**Comments on the Kentucky Pioneer IGCC Draft
Environmental Impact Statement**

Will Herrick
4859 Flat Mary Rd
Campton, Ky 41301

January 22nd, 2002

I have the following comments on the Kentucky Pioneer (KP) Integrated Gasification Combined Cycle (IGCC) Draft Environmental Impact Statement (DEIS).

Figure 4.4 Temperature Profile of ARBRE Gasification System

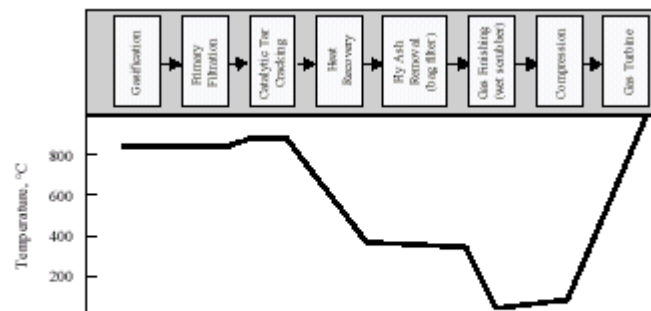
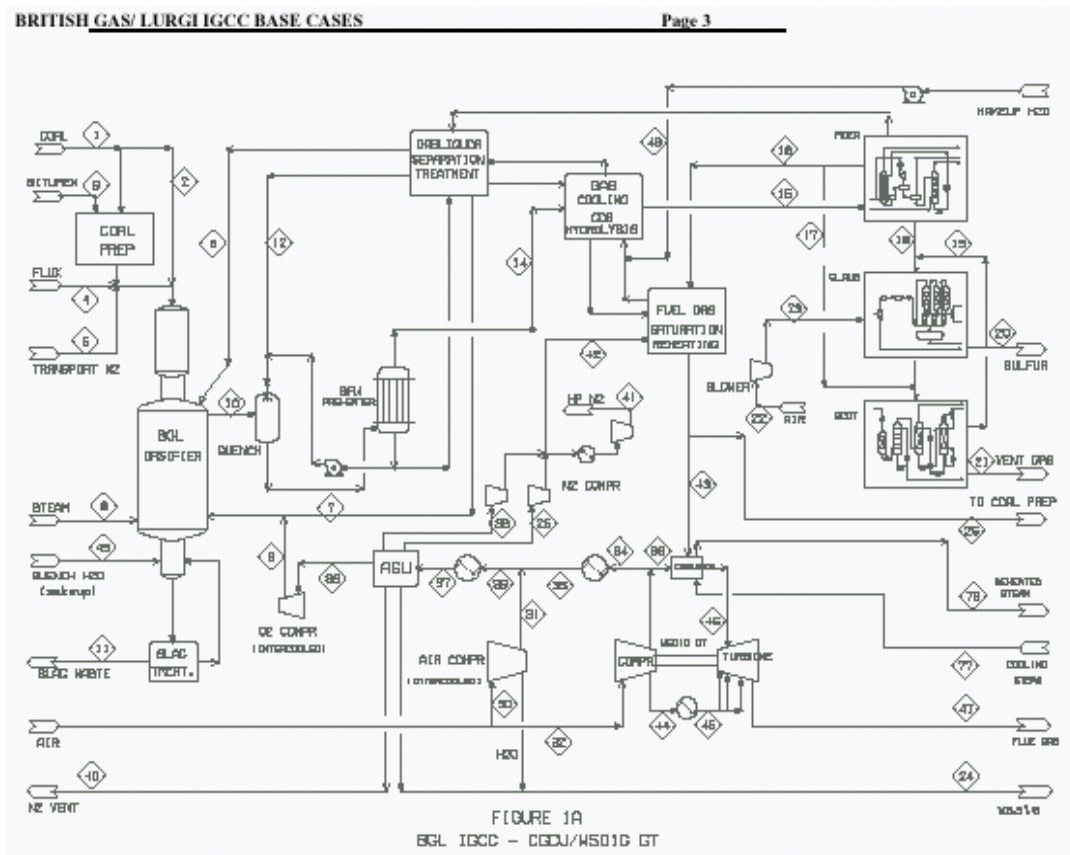
In the absence of information like that shown below, no analysis can be made about the fate of constituents. It is bordering on travesty that DOE published a DEIS absent of the essential design information needed to make any estimate of environmental impact.

The environmental impact of an IGCC plant is a function of the thermal and chemical character of the facility. Section 3.1.2 should address the temperature profile of the pyrolytic products. Examples of the types of information missing are offered below:²⁴
